CERTIFICATE OF APPROPRIATENESS

Property: 1913 A Crockett St, Lot 11A, Block 314, Crockett Street Landing Subdivision. The property is a vacant lot, subdivided into two lots – 1913-A, which fronts on Crockett St, measures 2,534 square feet (51’ x 50’-4”); 1913-B at the rear is 1,608 square feet (37’-8” x 42’-8”).

Proposal: New Construction – Residence

Construct a 2,310 square foot two story residence and attached garage.

BLOCKFACE RENDERING – FRONT FACING CROCKETT STREET

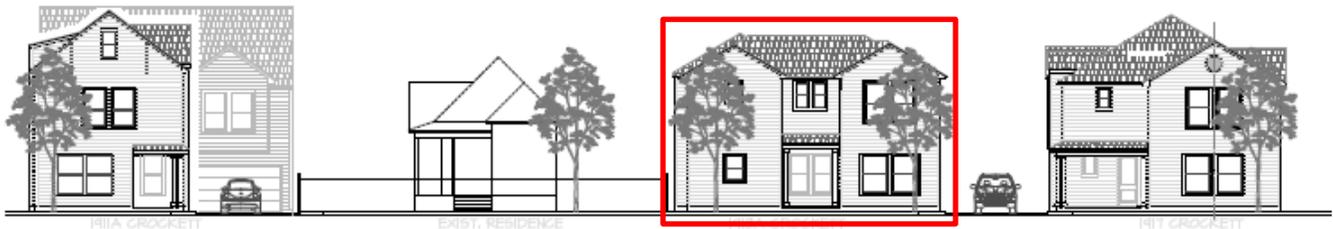
Staff comment: This drawing from the applicant does not reflect an accurate distance between the one-story contributing house at 1907 Crockett and the proposed structure. With only a 1' side setback, the new house will have less than 4' separation from 1907 Crockett.

EAST SIDE ELEVATION

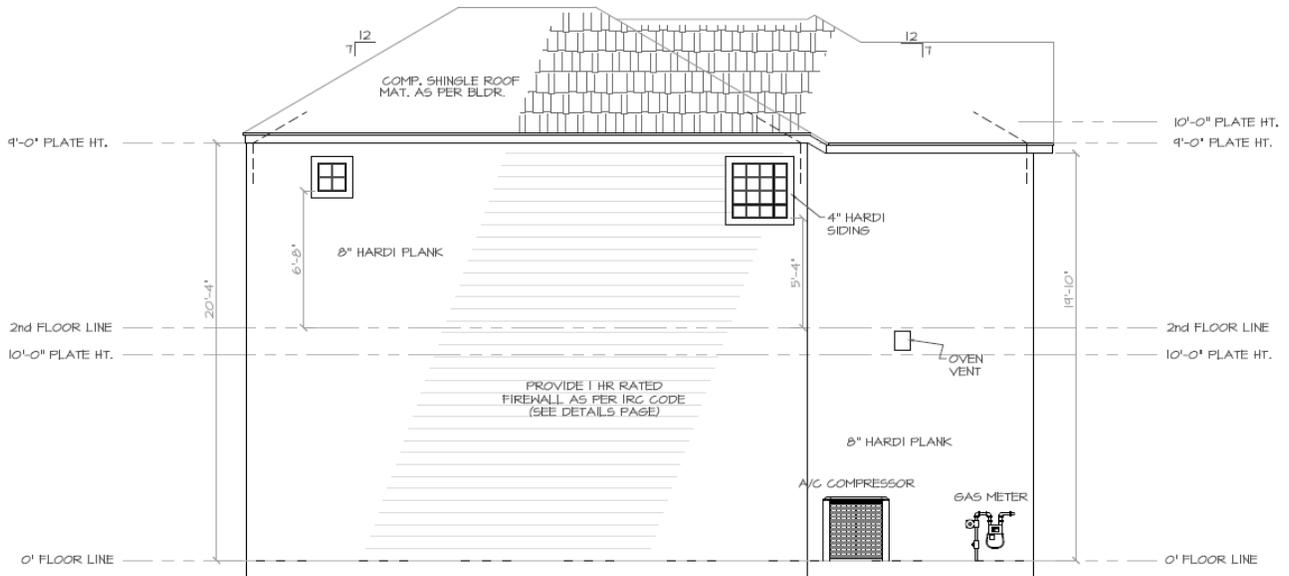
8" cementitious siding is not an appropriate feature within the context area. Smooth-finish 4" reveal cementitious siding would be a more appropriate siding option. The east elevation and the portion of the west elevation visible from the street are lacking window openings in keeping with typical contributing structures in the area. These blank walls do not meet Design Guidelines provisions requiring traditional solid-to-void proportions for walls to windows.

The draft Design Guidelines also require traditional solid-to-void proportions for walls to windows. The east and west elevations visible from the street lack window openings, which is not in keeping with typical contributing structures in the area and therefore does not meet this provision.

SITE PLAN
EXISTING

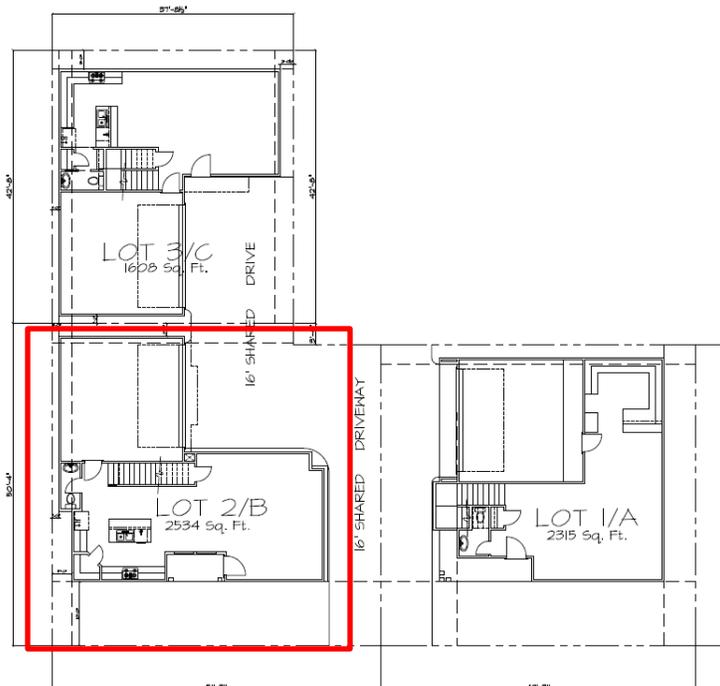
There is one contributing structure on this blockface that has a setback of 11'. The current proposal has a setback of 10'. The proposed east side setback is only 1', which is not typical of contributing structures in the context area. With a 1' setback, the new residence will be situated only 4' from the contributing structure at 1907 Crockett. With such a small separation, the height and width of the structure will overwhelm the contributing structure next door.

- 1.4. The historic/contributing structure at 1907 Crockett is known to encroach on its neighbor to the west (1913 Crockett). This encroachment is not shown on the site plan. This omission is significant, since it affects the actual distance that will separate the new structure at 1913 from the existing one at 1907.

- 1.5. A 10' setback from the street is noted. This is out of character for the District, where setbacks of 15 feet or more are prevalent on contributing structures. Is this permissible?
